## PLANNING COMMISSION

Monday, September 22, 2014

a. Consider a Site and Design Review & Conditional Use Permit from Verizon Wireless to construct a 100' Monopole with 12 – 8' panel antennas with the tip of antennas at a height of 104', ground equipment installed on a 22' x 3.5' concrete pad, with a 30kW backup generator installed on a 10' x 5' concrete pad, all within a 50' x 50' lease area surrounded by a secure chain link fence with screen slats topped with barbed wire at this unmanned site. **(DR 14-02/CUP 14-01)**

Prepared for the September 22, 2014 Planning Commission Meeting

**ELECTRICAL SITE PLAN**

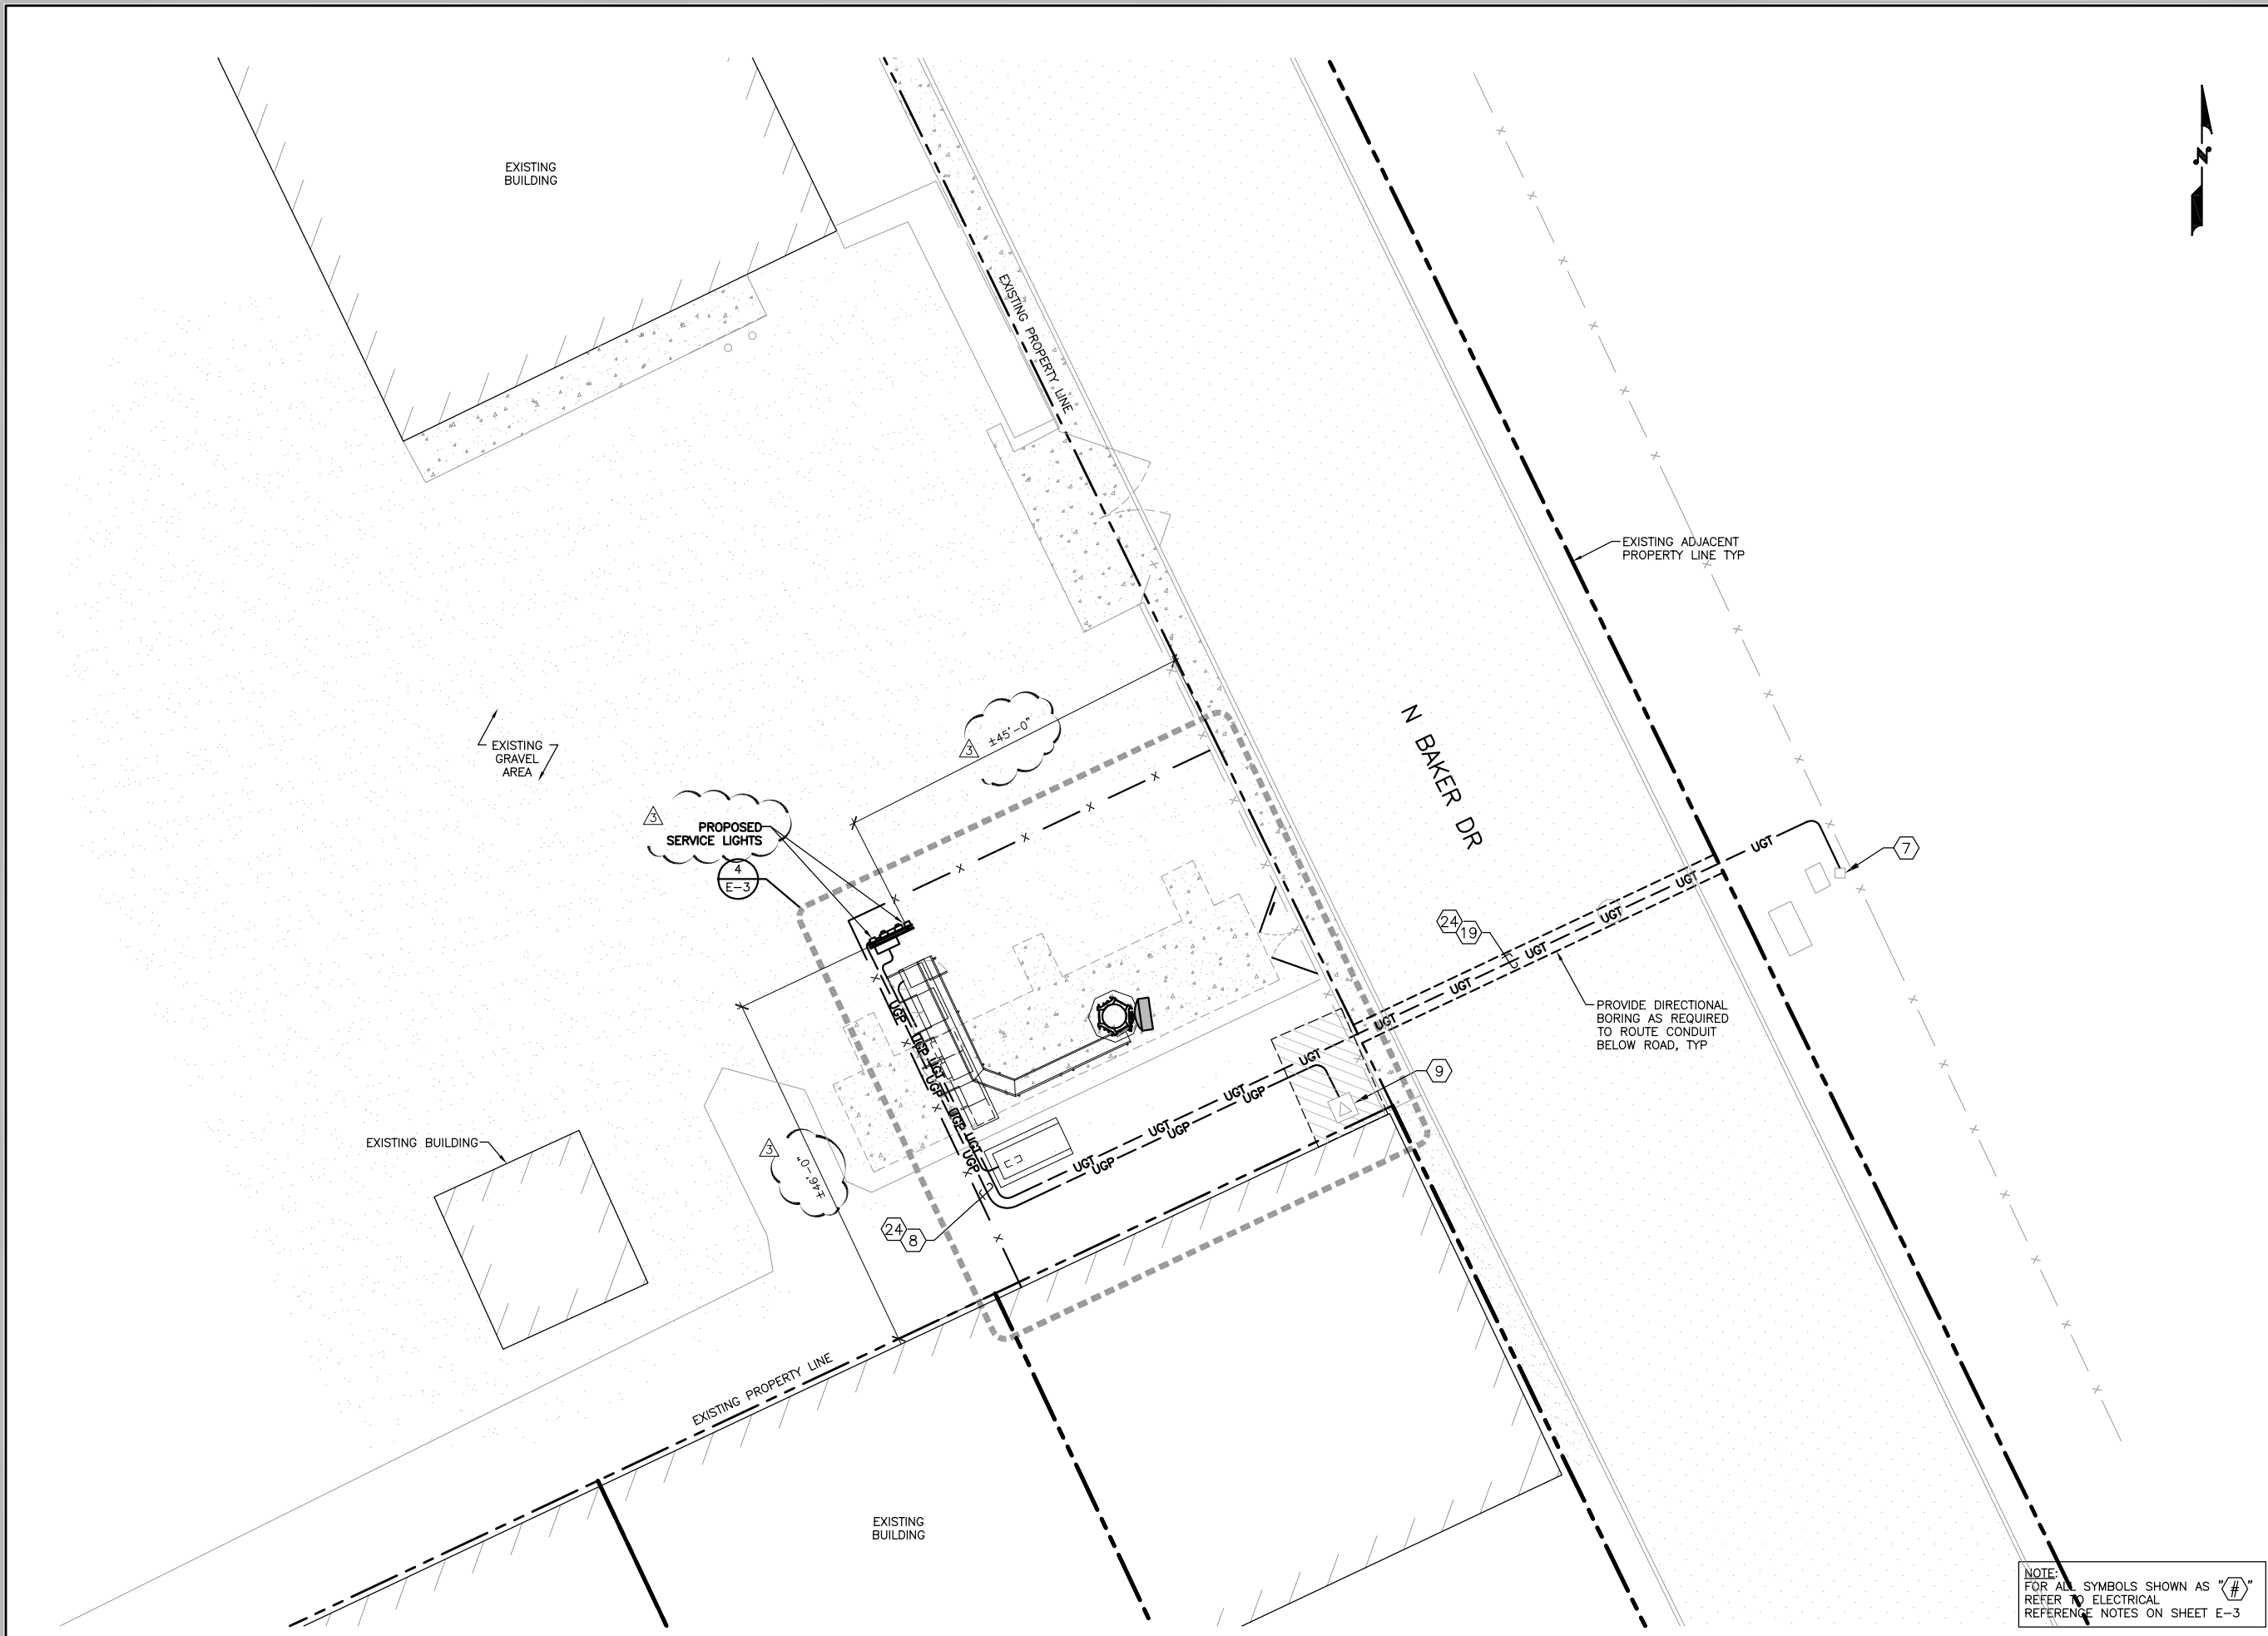
**Findings:** Per drawing E-2, the proposed pole lights are to be installed ~45ft from the property line. Per drawing E-6, 6 foot poles are proposed. The height of the pole mounted light must be the lesser of the 15’ height in the table above or the formulae (0.4 \* 45=18’). The proposed 6’ height is less than the maximum of height of 15 feet allowed in the Table which is the lessor of the two. The height standard is met.

Response: Proposed service lights comply with table 16.43.070 (see attached specs). Proposed lights do not exceed mounting height of 40% of the horizontal distanced from the property line or maximum heights specified on table 16.43.080 (Detail 1 on sheet E-6 has been revised to show the height of the proposed lights and sheet E-2 has been revised to show lights setback form property line)
